## **APPLICATION FOR RESOURCE CONSENT RMA/2019/1330, 25 OXFORD STREET AND 3, 5, 7 AND 9 LONDON STREET**

1. The letter below sets out the proposed changes to the plans for the above application, noting the updated plans that were sent to Council on 14 January 2020. These changes were undertaken following consultation with the Council and are contained within **Attachment 4**.

## Attachment 1: Amended District Plan Parking Requirements

04 | plan: site: sketch  
 scale 1:500 @ A3

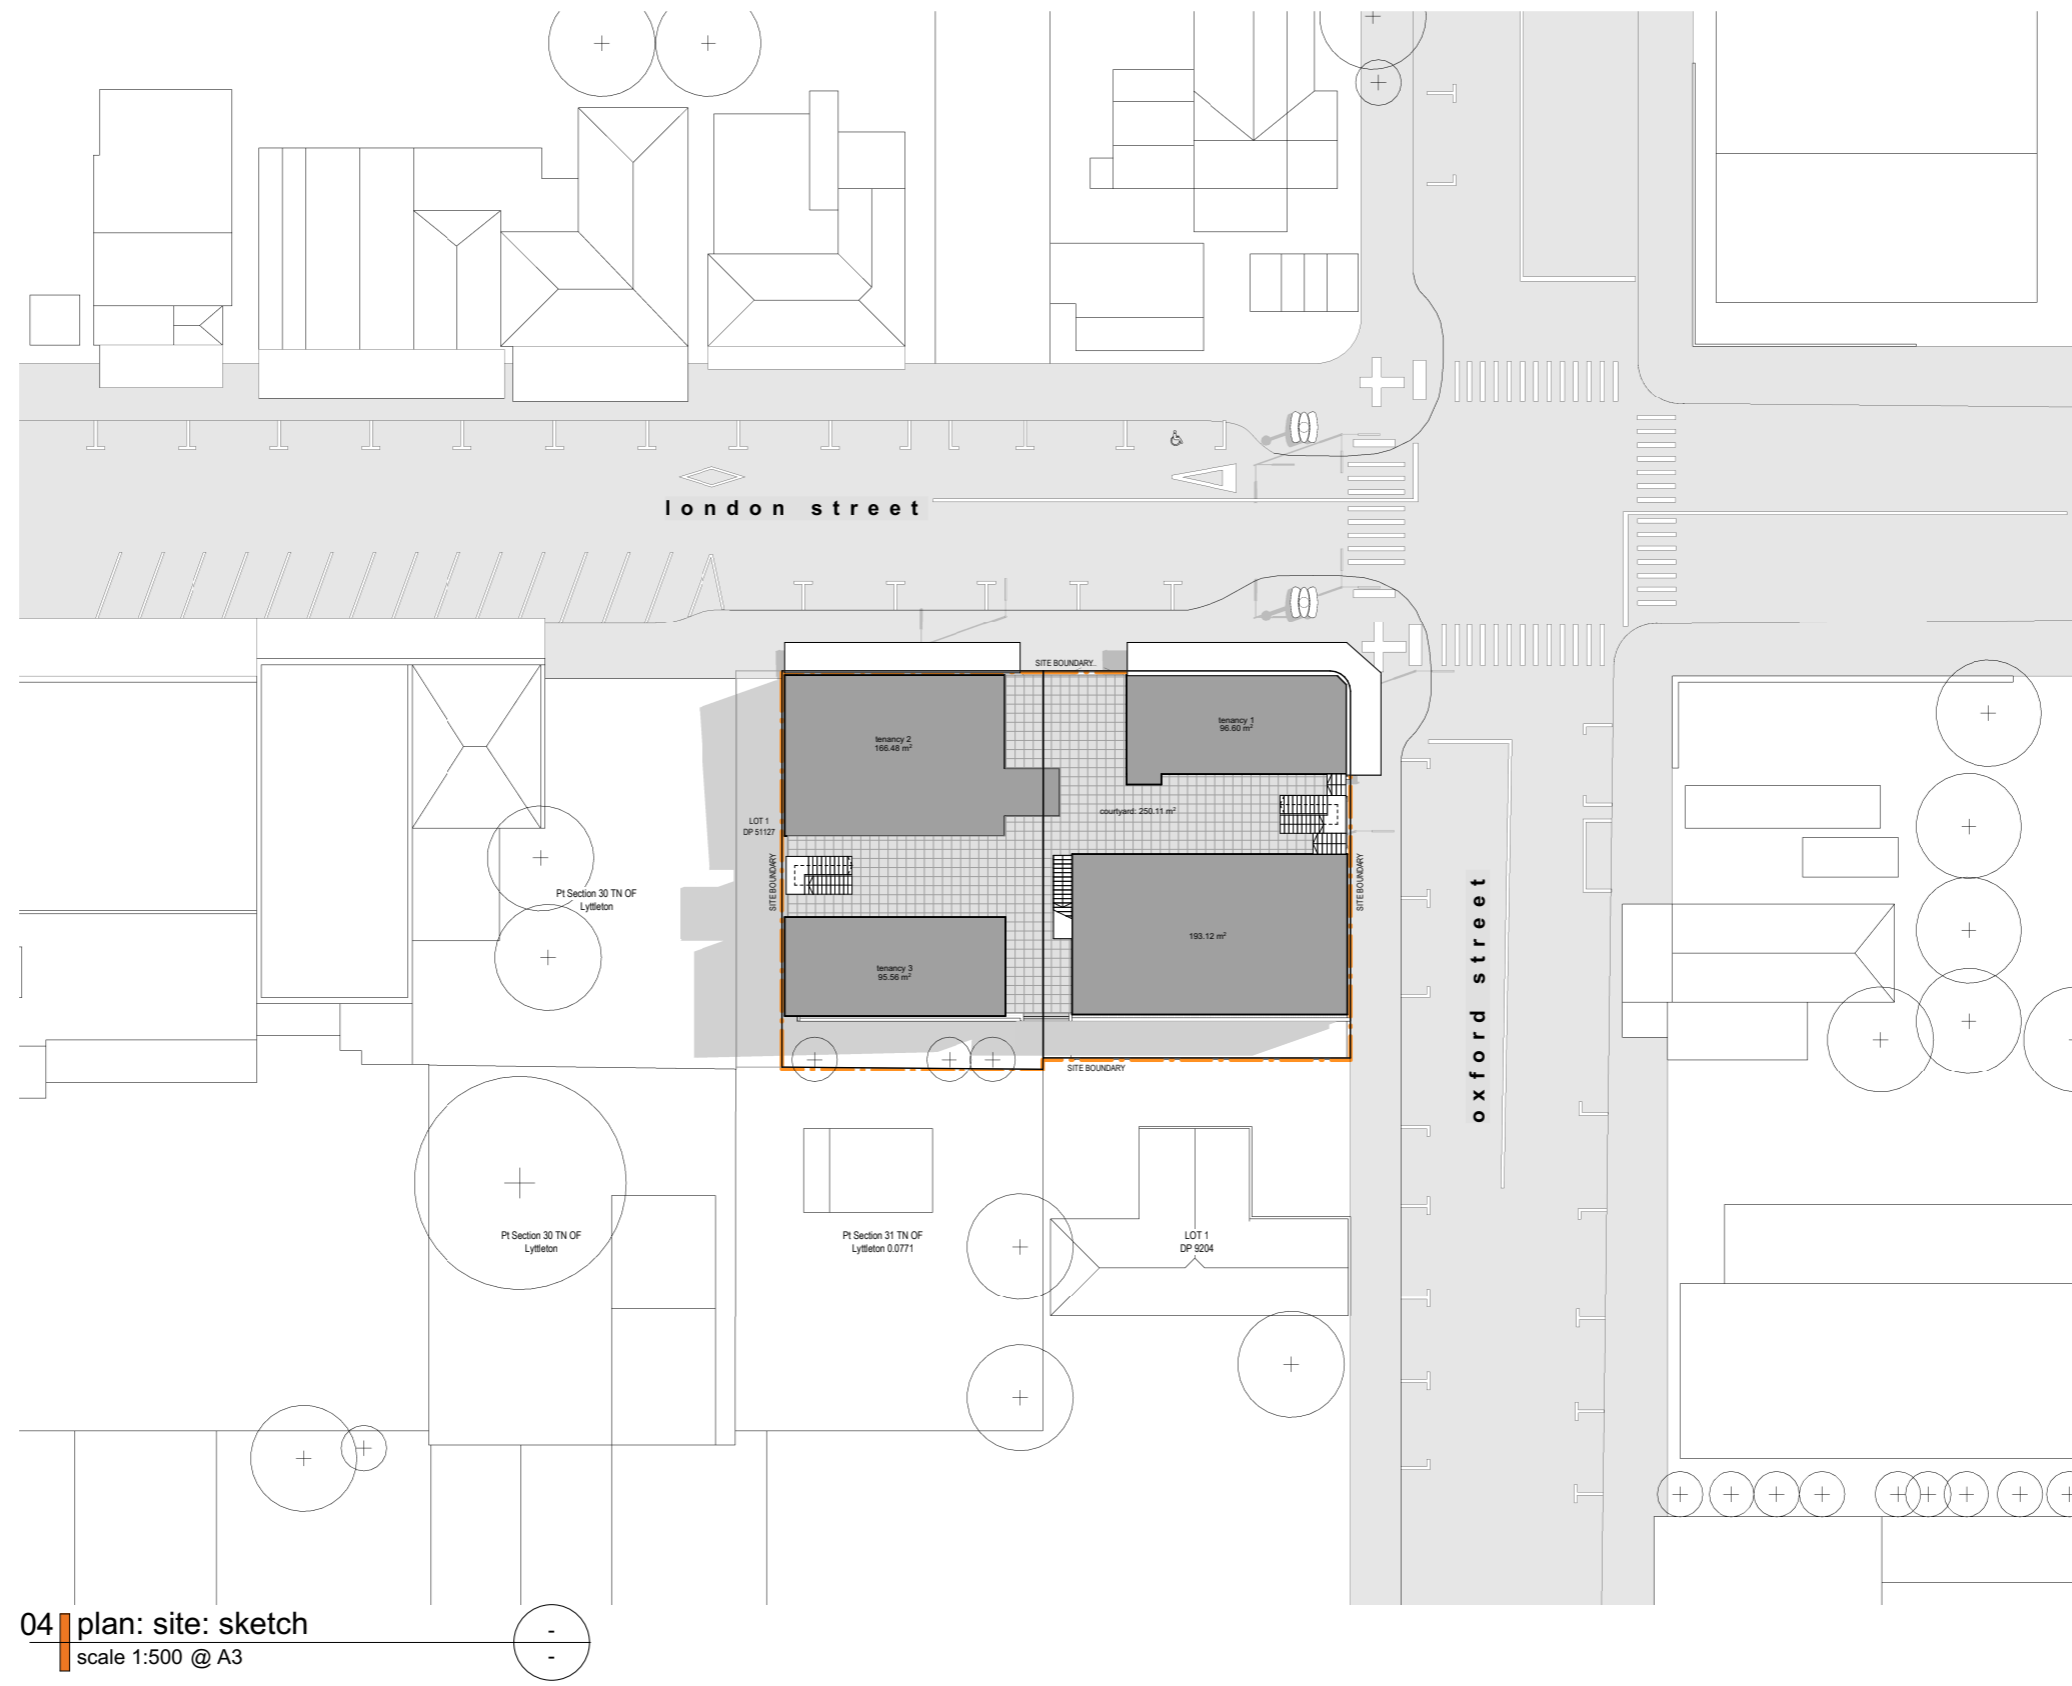
- The building has been moved closer to the western boundary with the two building blocks along the western boundary moved. The blocks have been moved to create a more generous space between buildings;

01 north elevation  
scale 1:200 @ A3

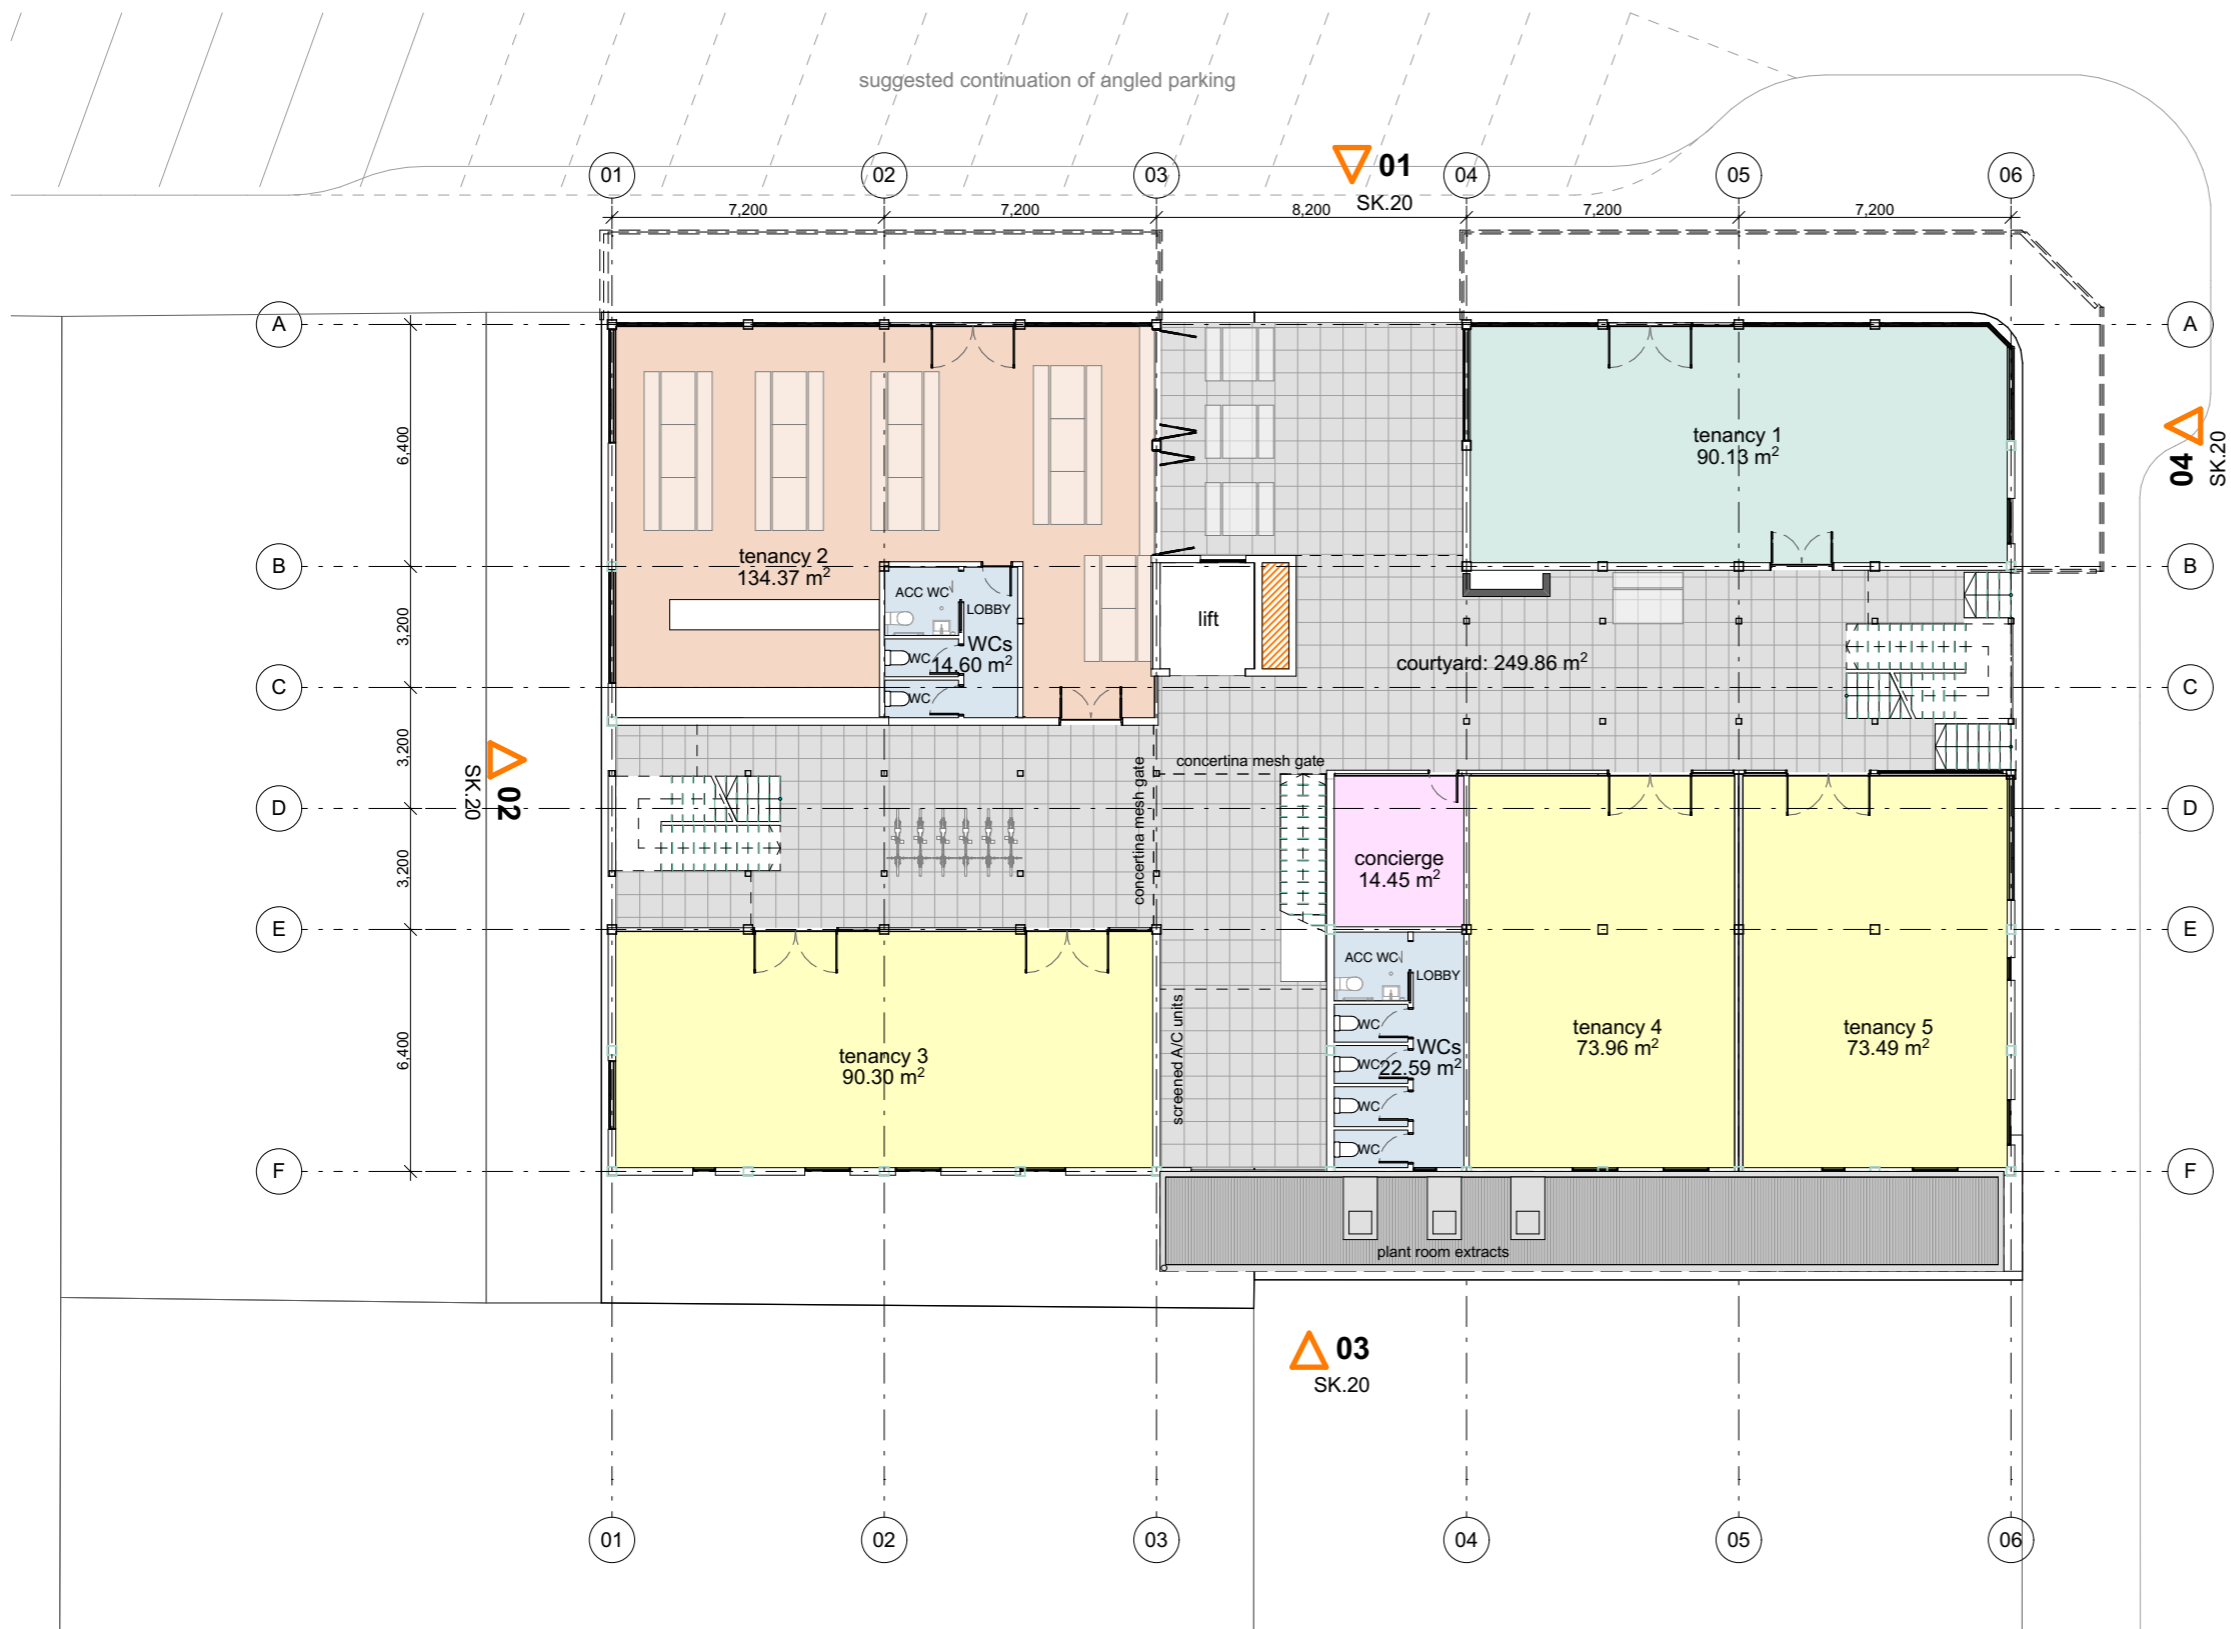
- The glazed area at ground floor has been updated due to fire engineer input. The updated glazing area has resulted in a decrease in glazing from 68% to 67% along the northern elevation and an increase in the amount of glazing along the eastern elevation from 22% to 37%. The development will continue to infringe Rule 15.6.2.3 as the building's eastern elevation is not provided with a minimum of 60% glazing and the building's veranda is not proposed to run along the full length of the Oxford Street road boundary;

North elevation:  
Ground floor glazing = 67% of ground floor facade

04 east elevation  
scale 1:200 @ A3

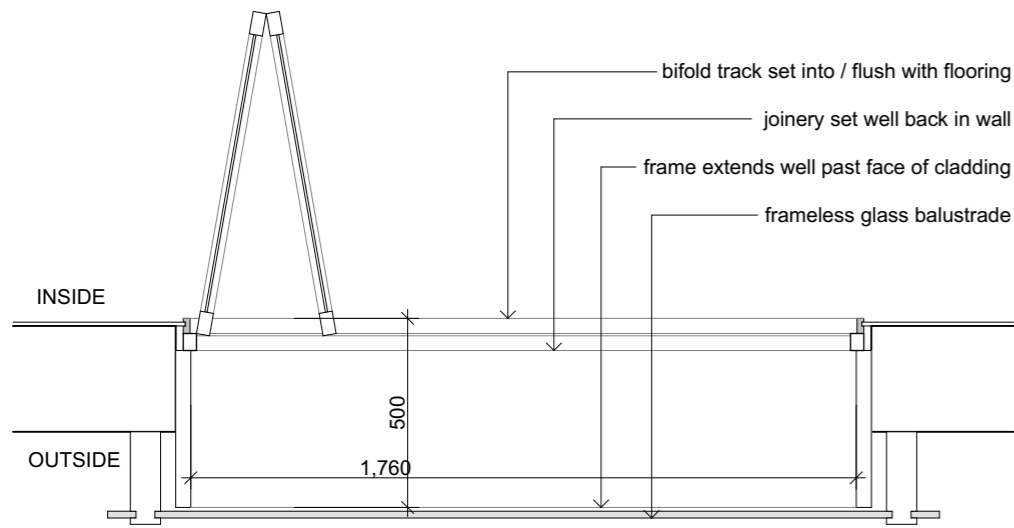
East elevation:  
Ground floor and basement glazing/openings = 37% of facade

**A** juliet balcony detail  
scale 1:20 @ A3

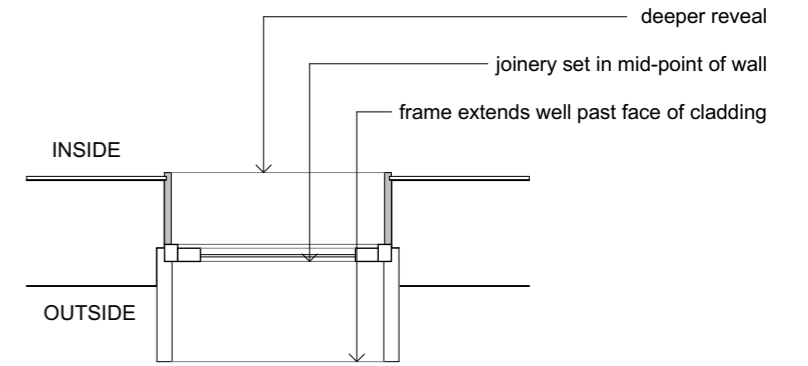
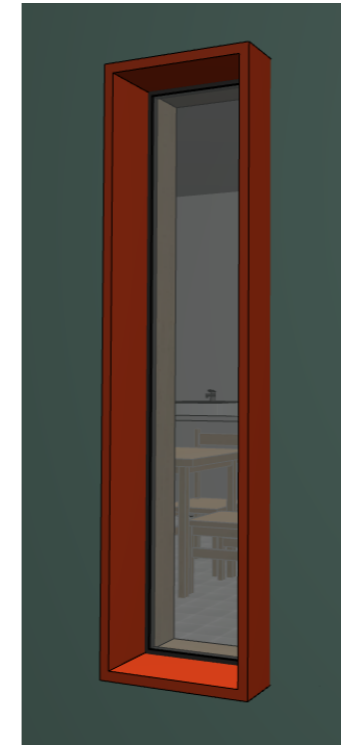
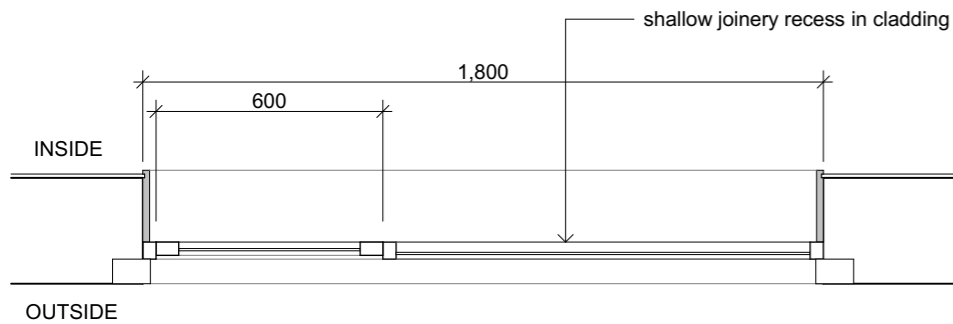
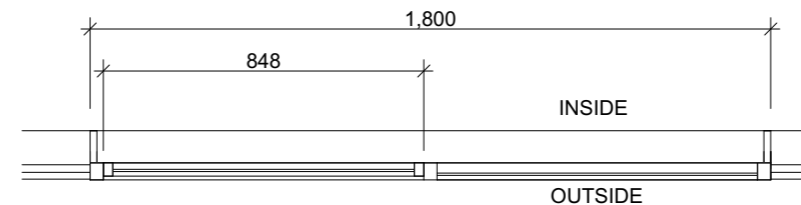
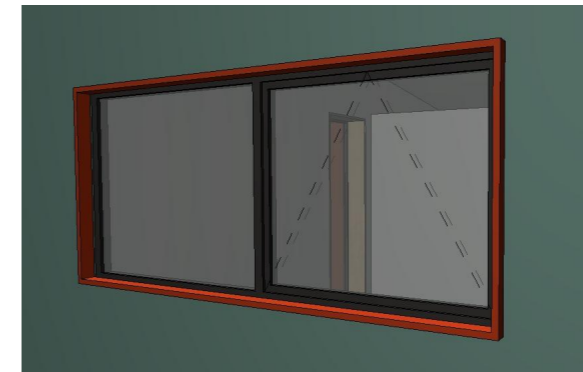
- Developed window details to show a range of window types and their location and to demonstrate the proposed Juliet balcony windows;
3. The proposed changes will not result in any additional non-compliances, while the existing non-compliances that were proposed under RMA/2019/1330 are detailed above and below in the transport amendments.
